SHERWARD G. FARNSWORTH, P.E.
Project Manager - Structures Section
VERMONT AGENCY OF TRANSPORTATION
National Life Building - Drawer 33
MONTPELIER, VERMONT 05633-6001
Telephone (802) 828-3874 Fax (802) 828-3566

LETTER OF TRANSMITTAL

DATE: 2-13-2002
CONTRACT No.
PROJECT Name: SR BURLINGTON
PROJECT NO: IM 0209(36)

SUBJECT: Semi-Final Plans - South Burlington IM DECK(36) I-89, Exit 14
Relocation of Verizon conduit's and future relocation of Aldelphia's conduits from Williston Road bridge over I-89 >>>> Duct Bank Relocation <<<<

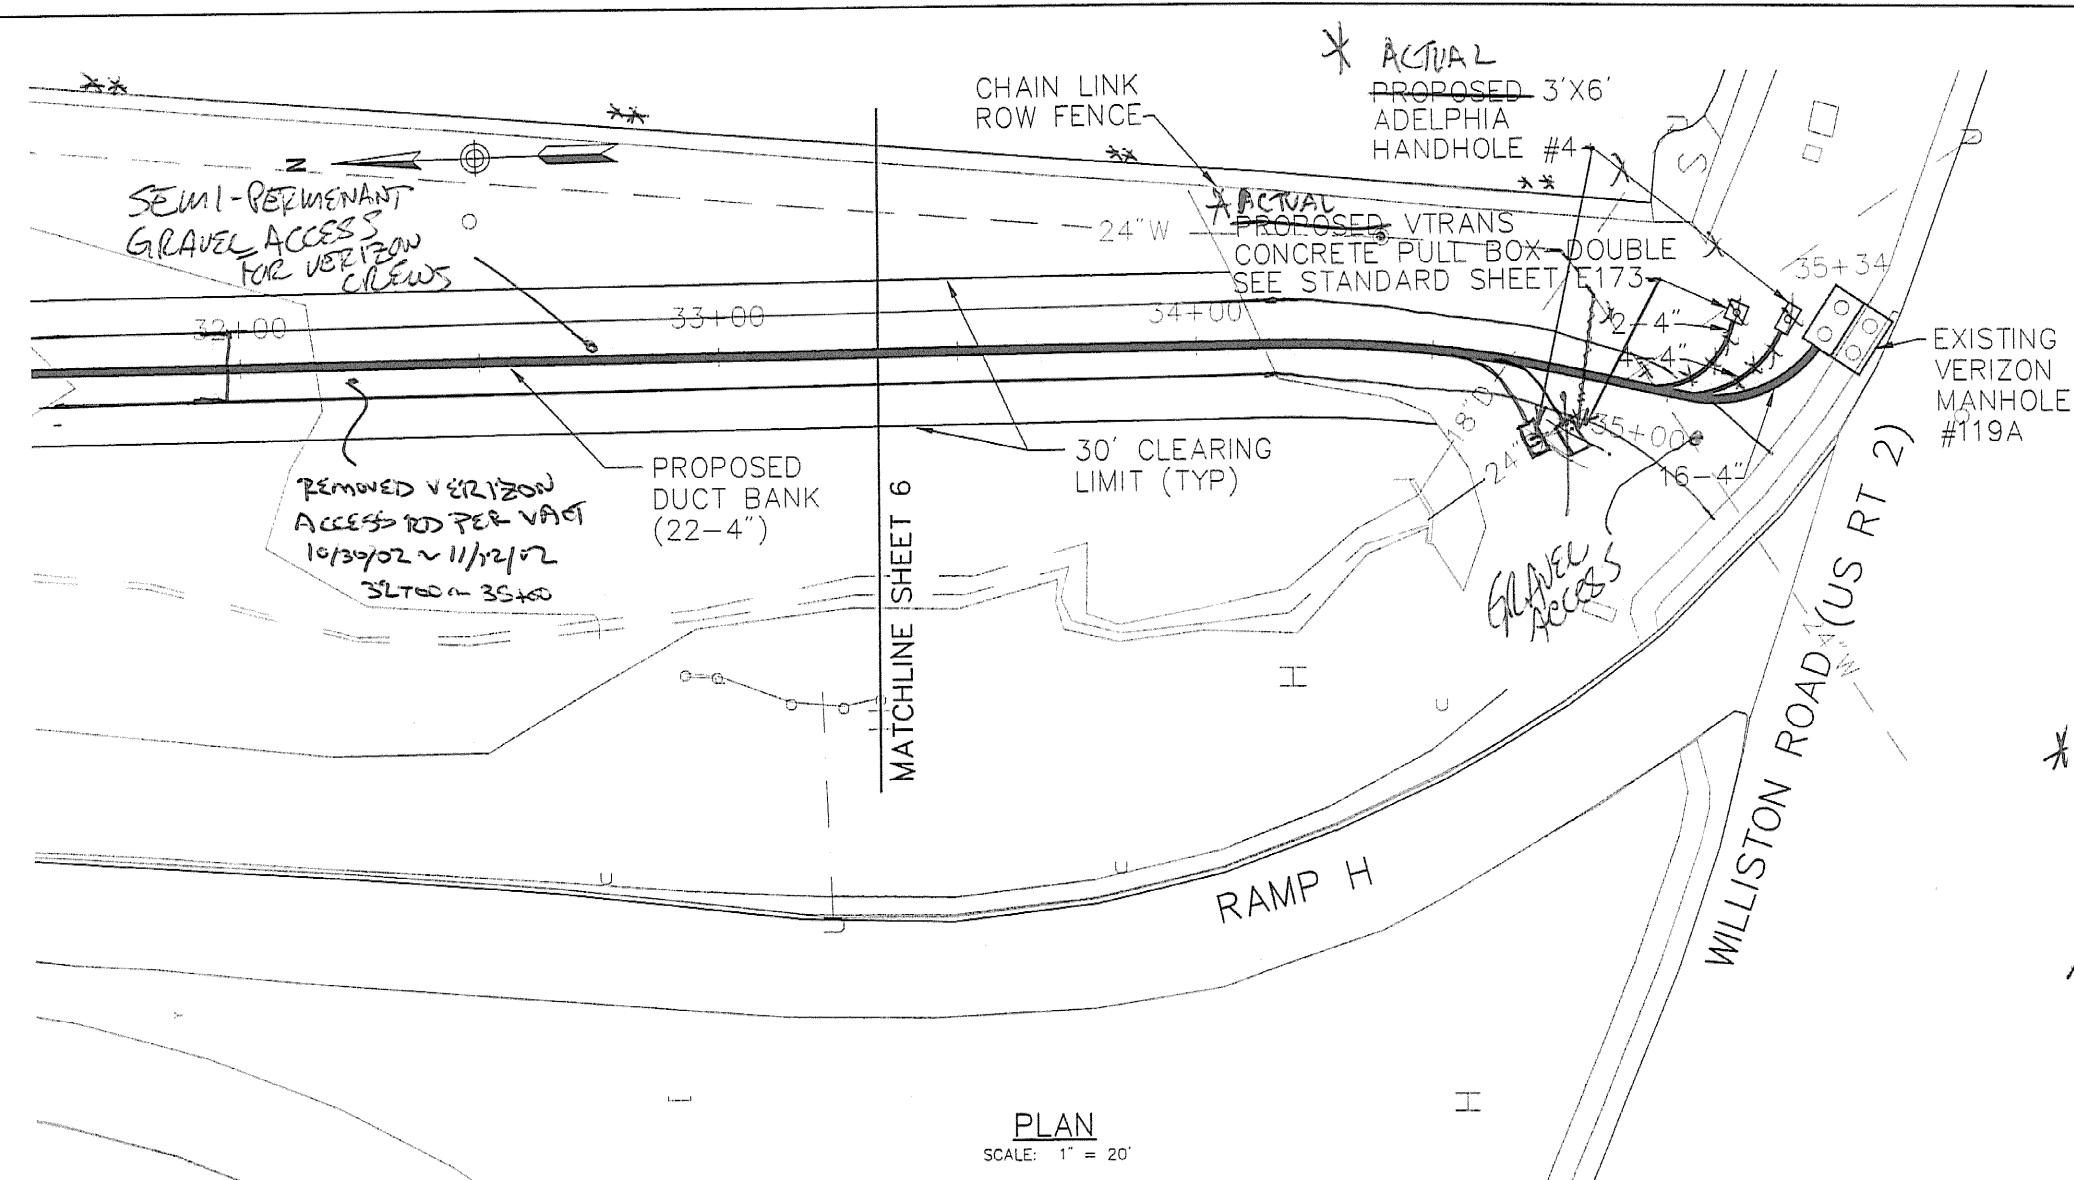
* FIELD CONDITIONS GAVE THE
NEED TO RELOCATE THE CATV &
VADT HANDHOLDS TO CLEAR
EXISTING 8\"/>

TYPICAL FRAME LAYOUT FOR SUPPORT
1/4" = 1'-0"

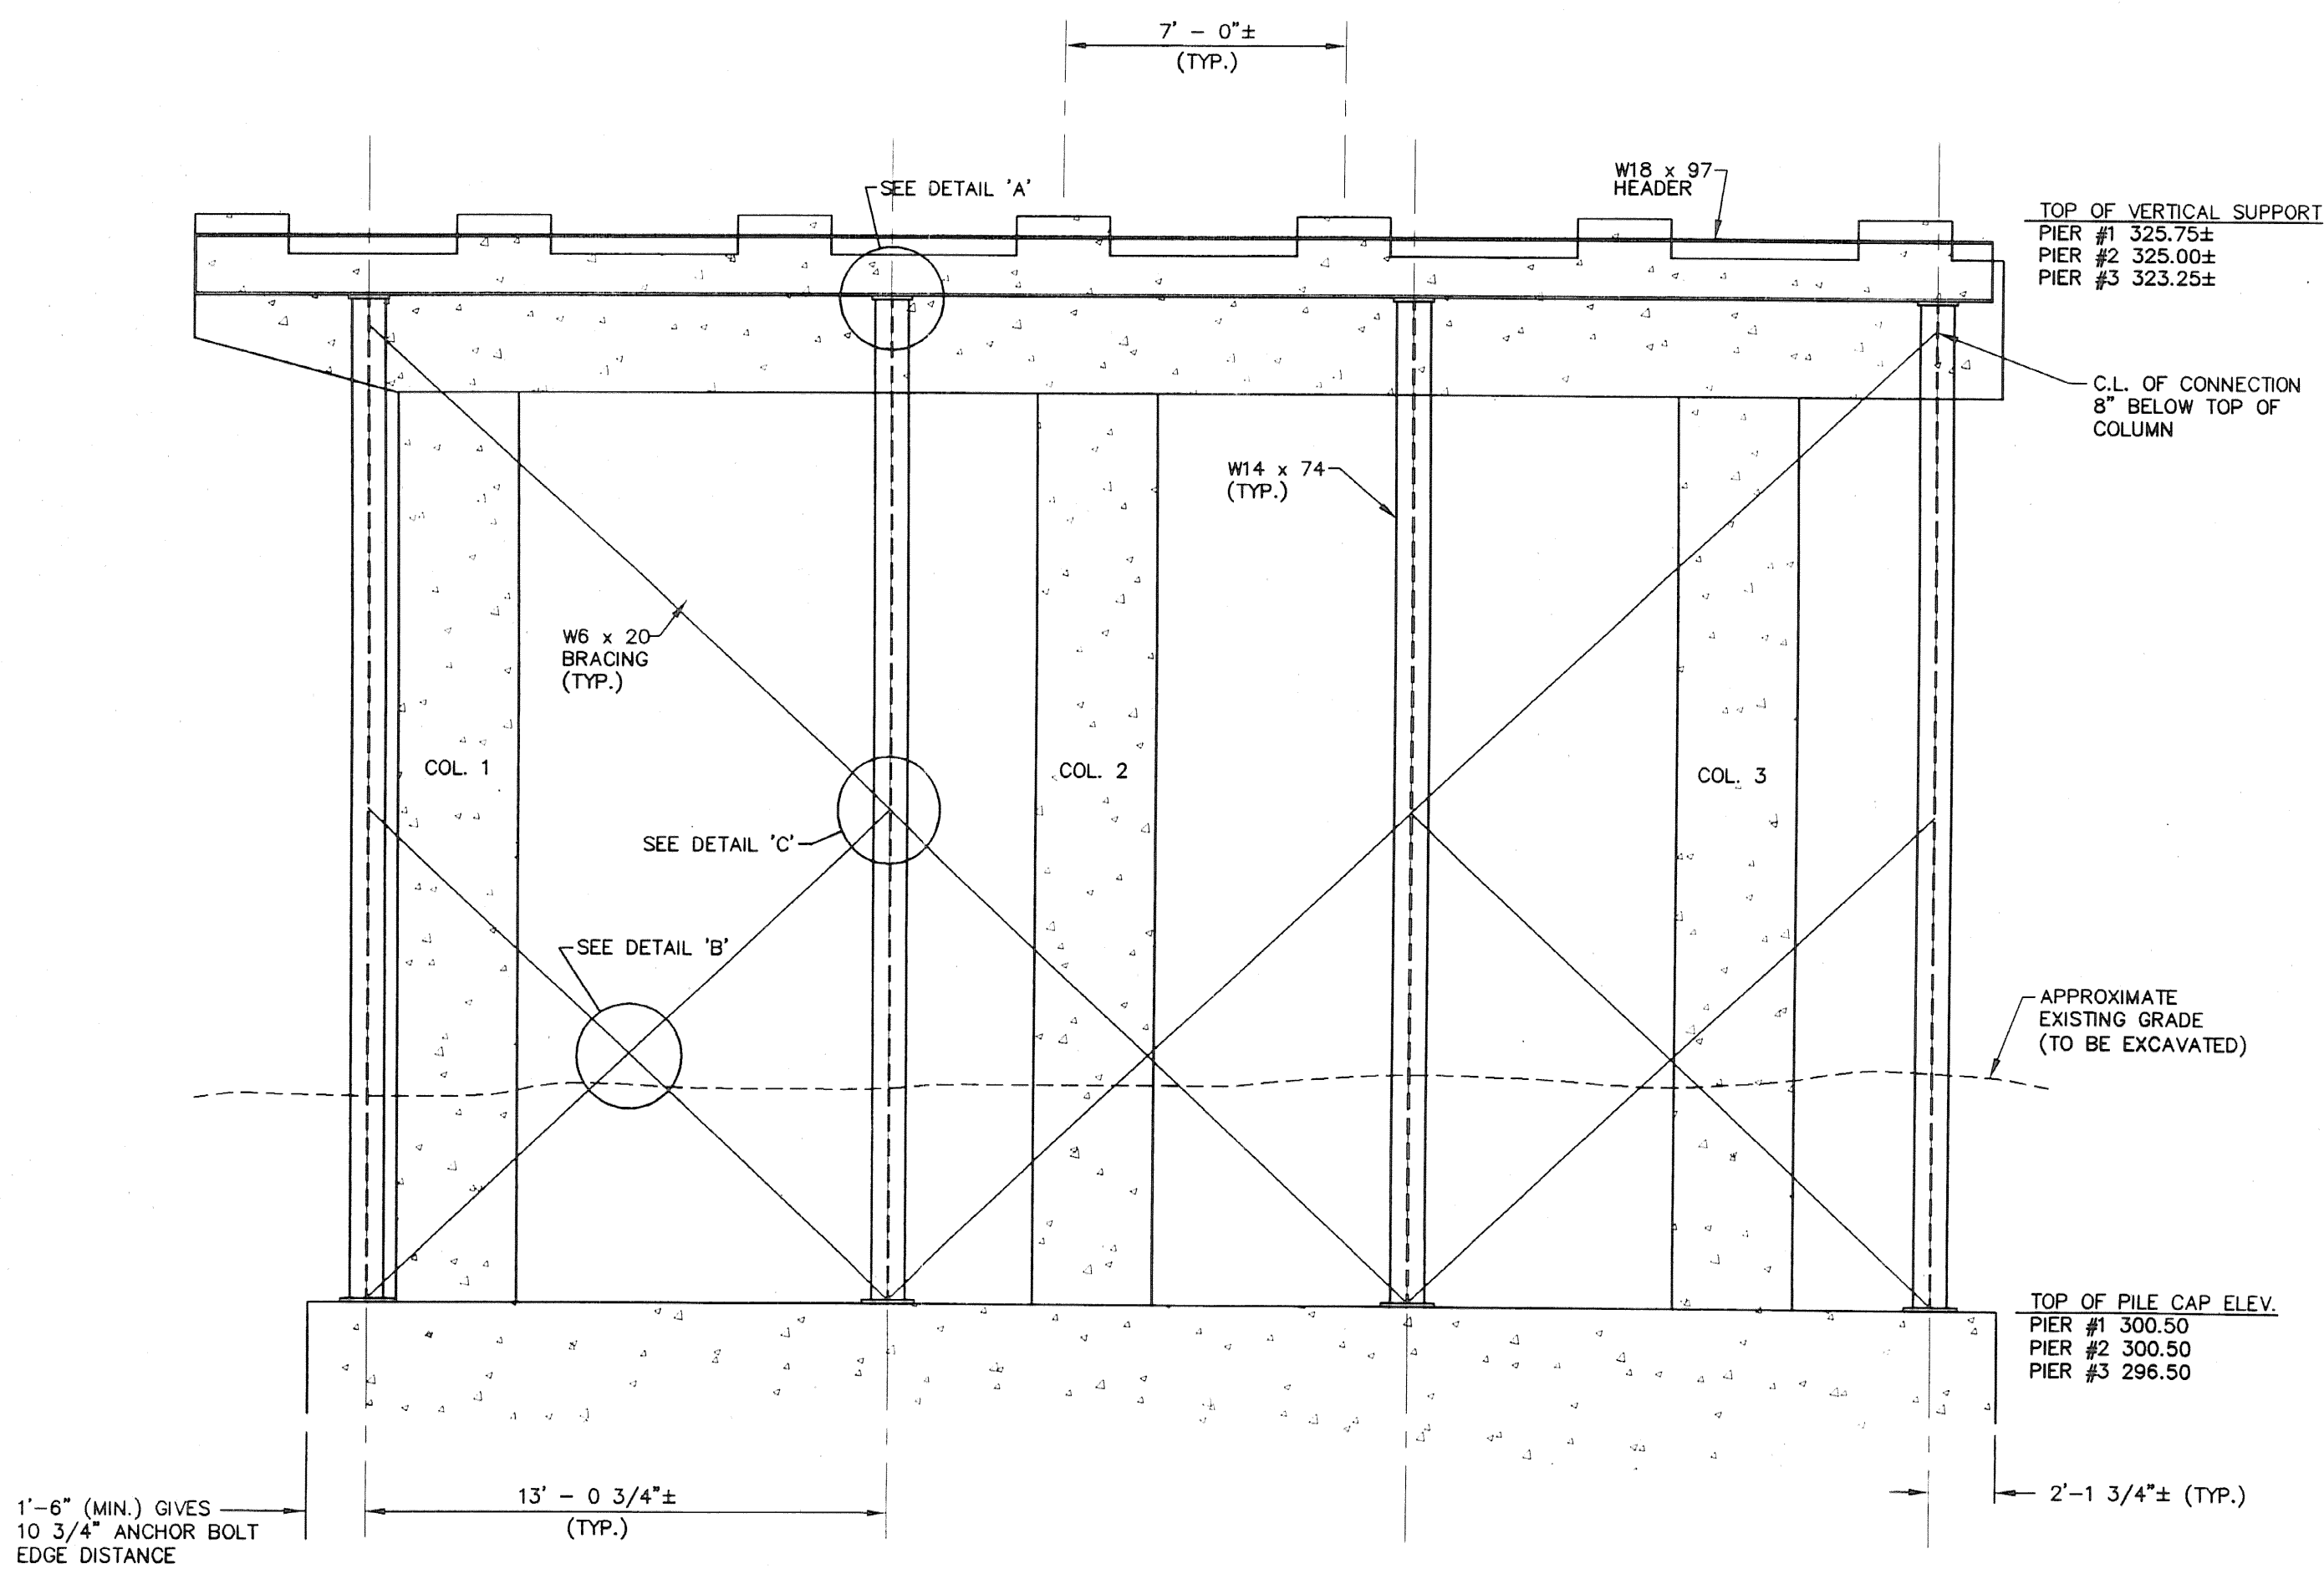
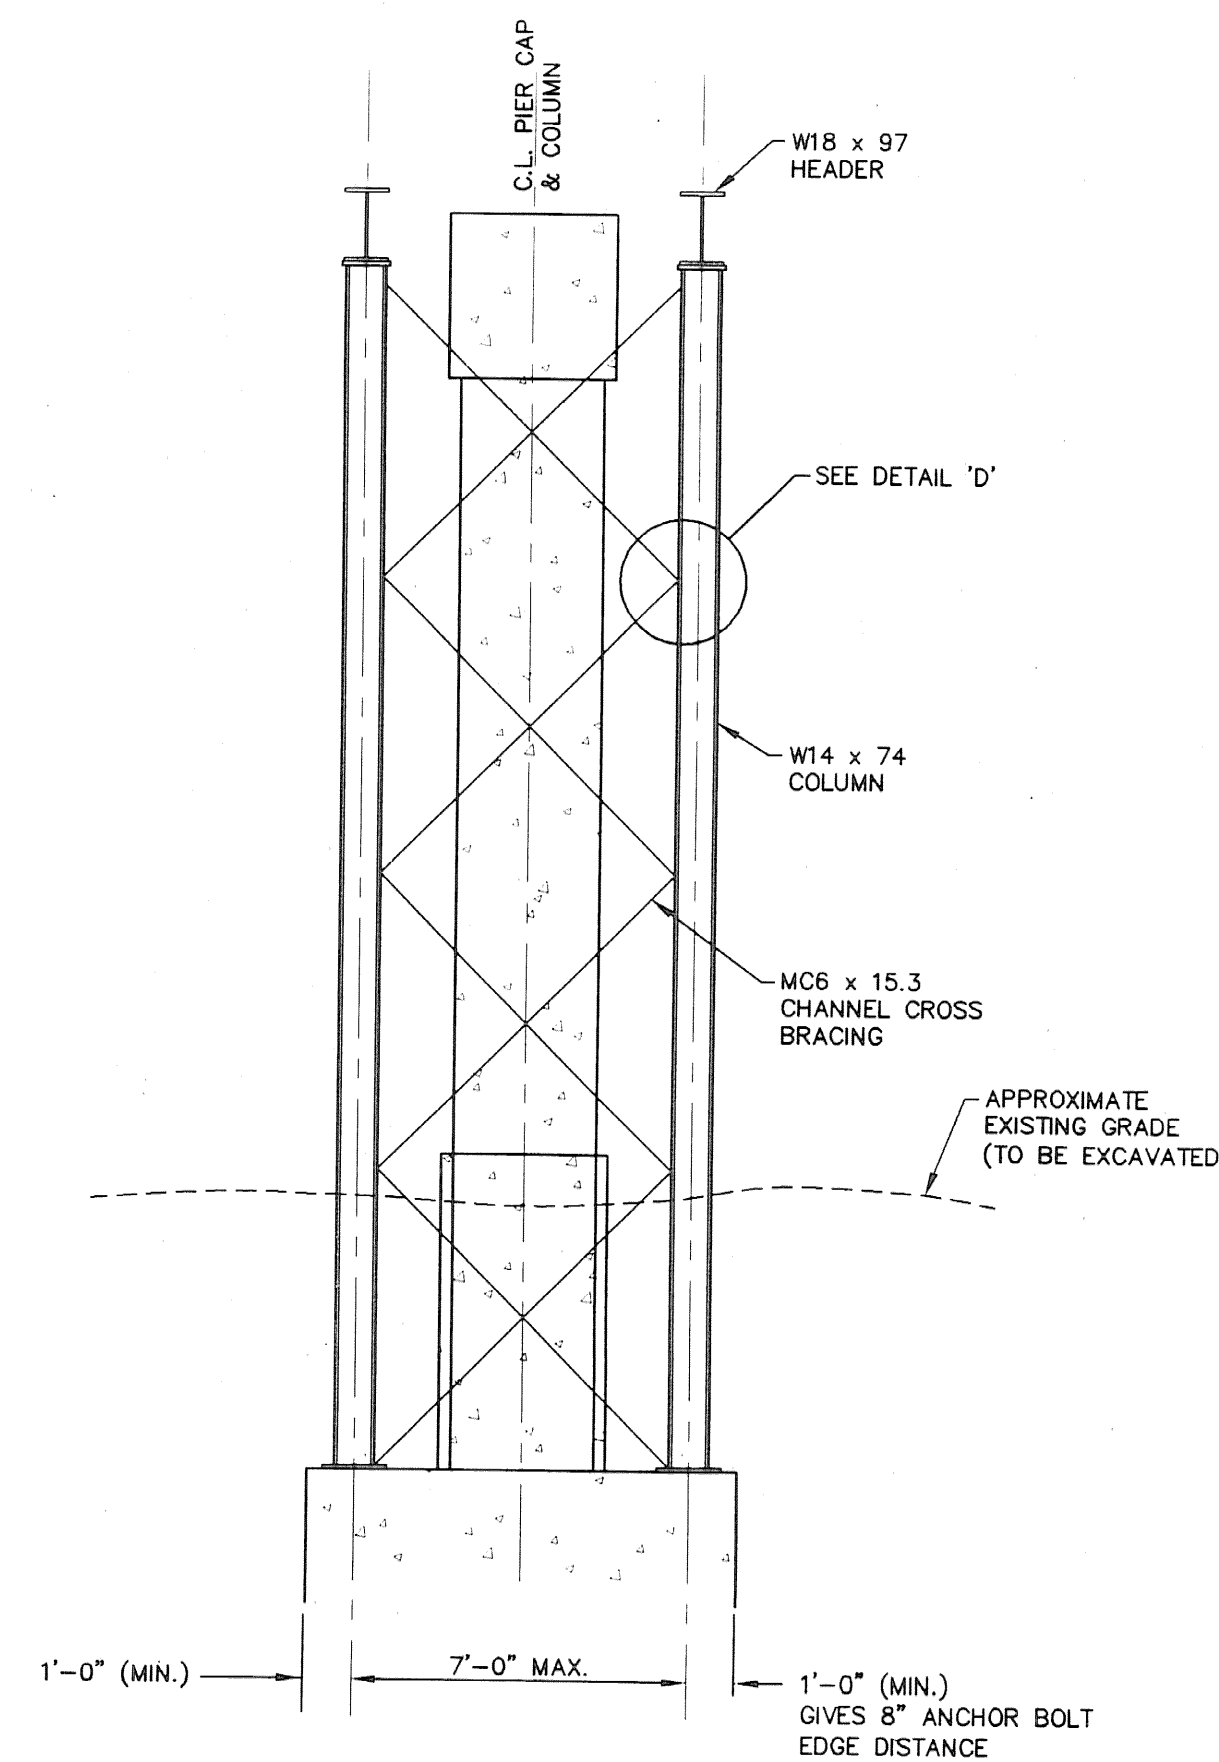
1. One end of each set of stringers will be "fixed" to the beam seat (stub columns) with two heavy duty C-clamps (Proto model 6-HDL shown on attached sheet). Lateral restraint at this "fixed" end will be a 6-inch length of minimum 1/2 inch thick steel welded to the top of the stub column bearing plate adjacent to stringer bottom flange.
2. The "free" end will be restrained against vertical and lateral movement by the detail shown as "E" on our drawing S1 revised June 27, 2000.
